KEYSTONE PARK BALL FIELD BACKSTOP/SIDELINE FENCE

ADDENDUM #1

KEYSTONE PARK
BACKSTOP / SIDELINE FENCE PROJECT

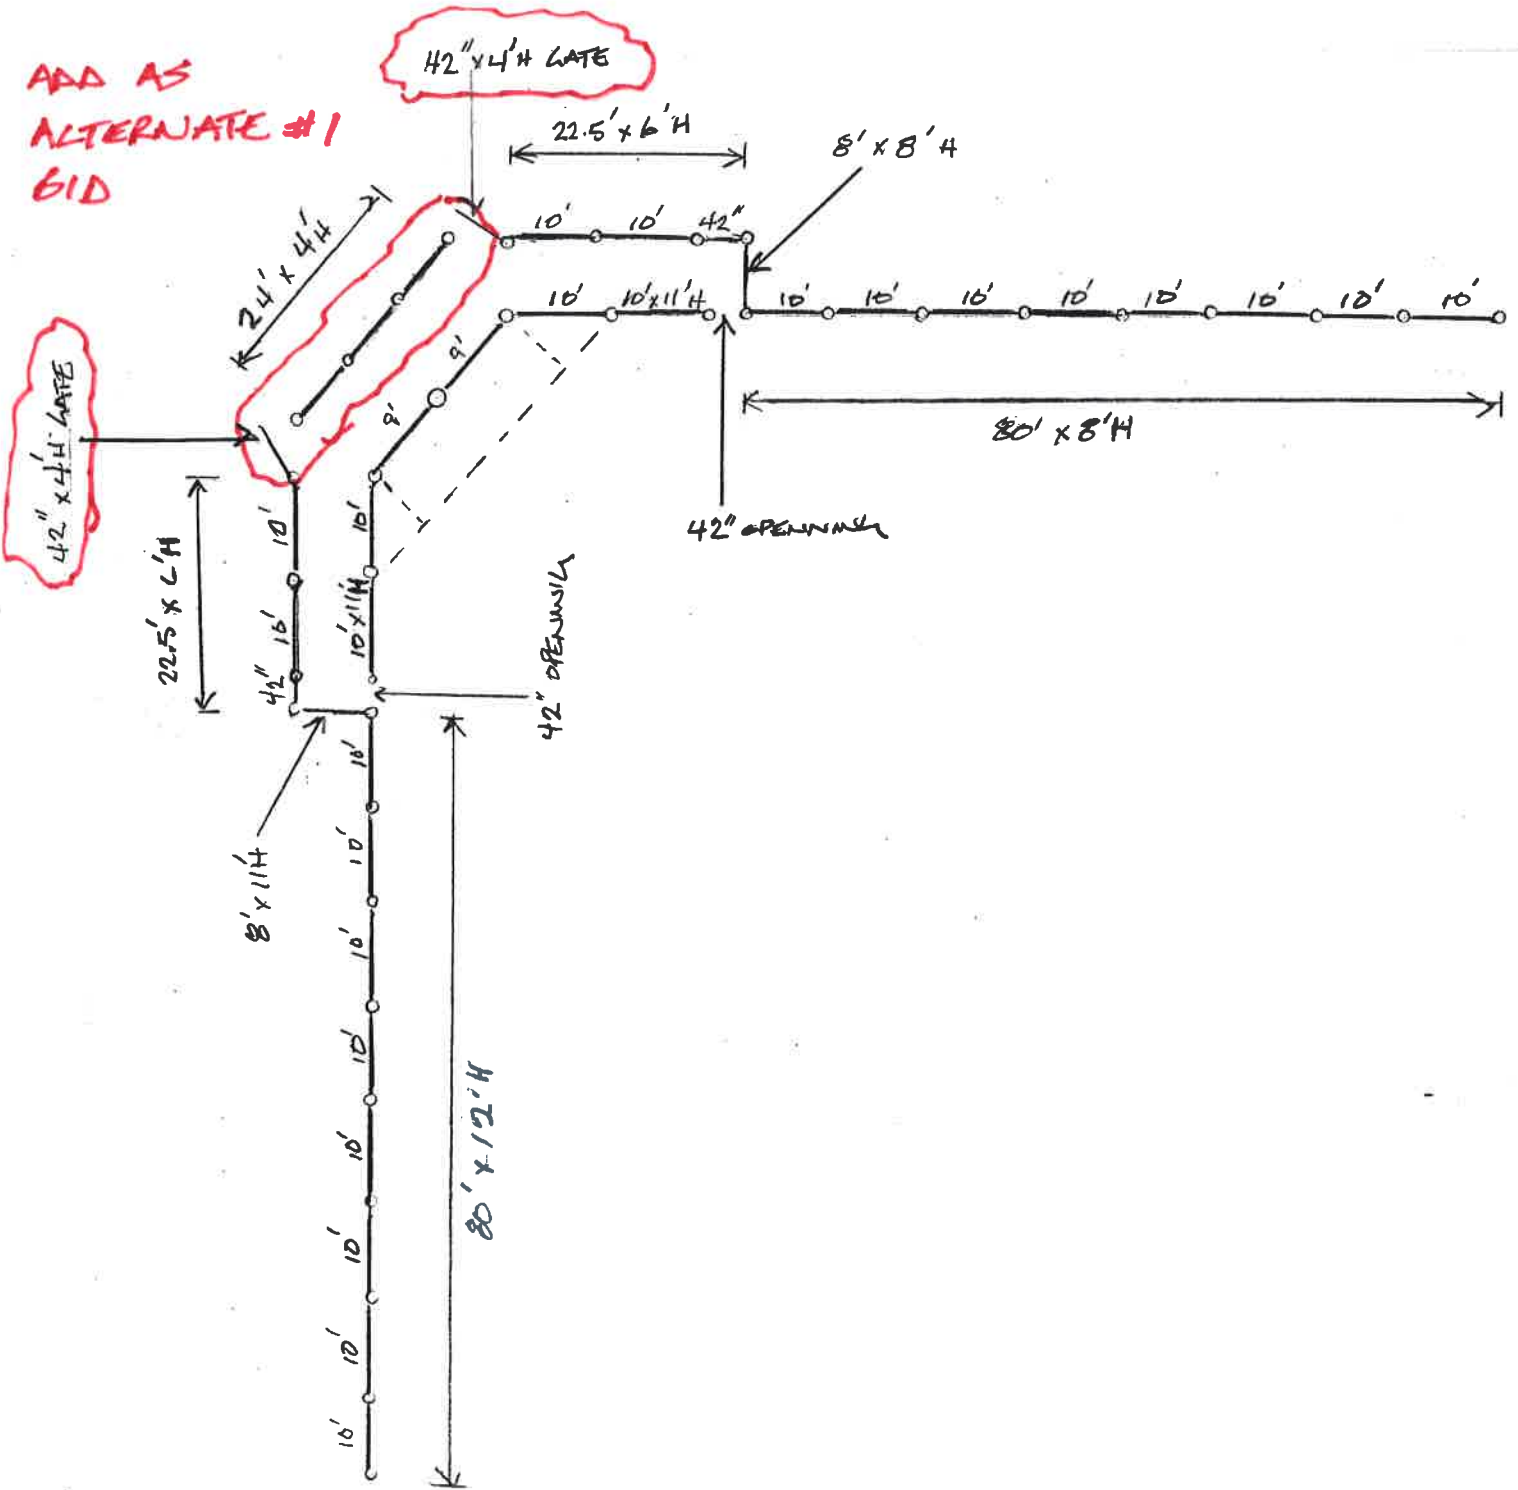
Remove the 24' x 4' high fence section and two (2) 42" x 4' high gates from the bid, and include as an Alternate #1. See attached plan.

ADD AS
 ALTERNATE #1
 BID
